Floor Plan — Rev R

REV R · 22 SEP 2026 10:46 AM
DRAWN ON LASER MEASUREMENTS

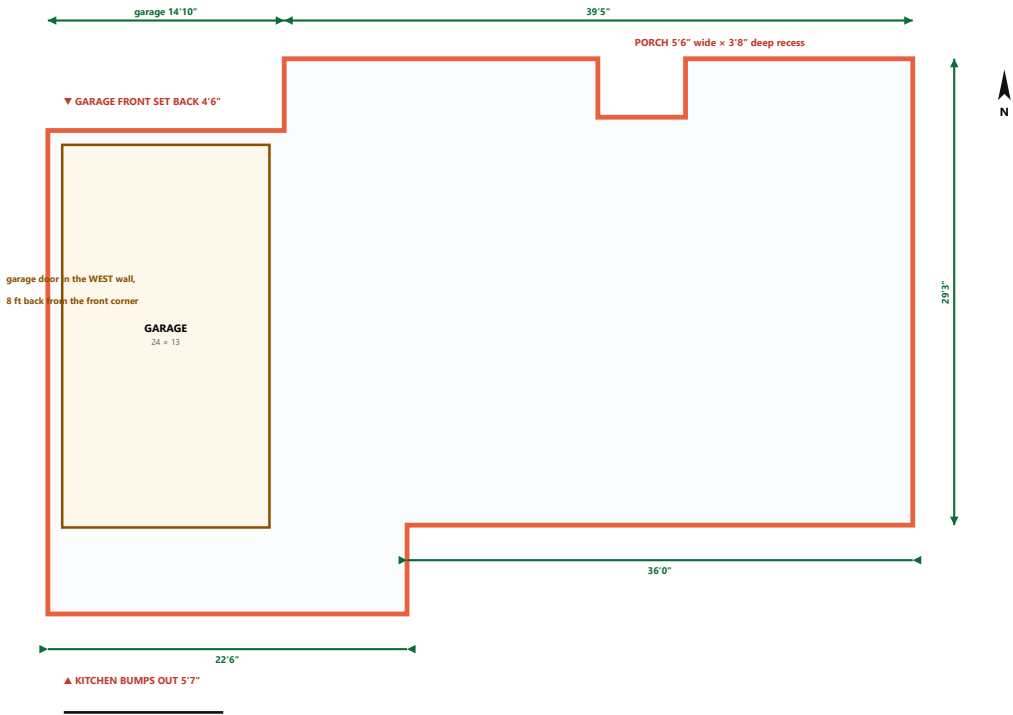
The first version of this plan drawn on **real geometry**. The outline is traced from your perimeter walk, which **closes in both directions to within inches. It is not a rectangle — and it never was.**

✓ **The shell is no longer a guess.** Every heavy line came off the GLM 20. The three steps that were on no previous revision are all here: the **kitchen bumping out 5'7"**, the **porch recess 3'8" deep**, and the **garage front set back 4'6"** with its door in the **west** wall.

⚠ **What is still mine, not yours.** The shell is measured; **where the rooms sit inside it is still fitted.** I have the room sizes but not their positions, so I have placed them against your corrections and the Sharky topology. **The dashed guest bath is arithmetic off your 26'6" chain, not a measurement.** Check the arrangement — the outside walls are right.

→ **What I need from you to finish it:** just **which room is next to which** — no more tape. Walk the house and tell me the order, e.g. "out of the foyer,

living room is straight ahead, kitchen on the left, hall to the right.” The sizes are settled; only the jigsaw is open.
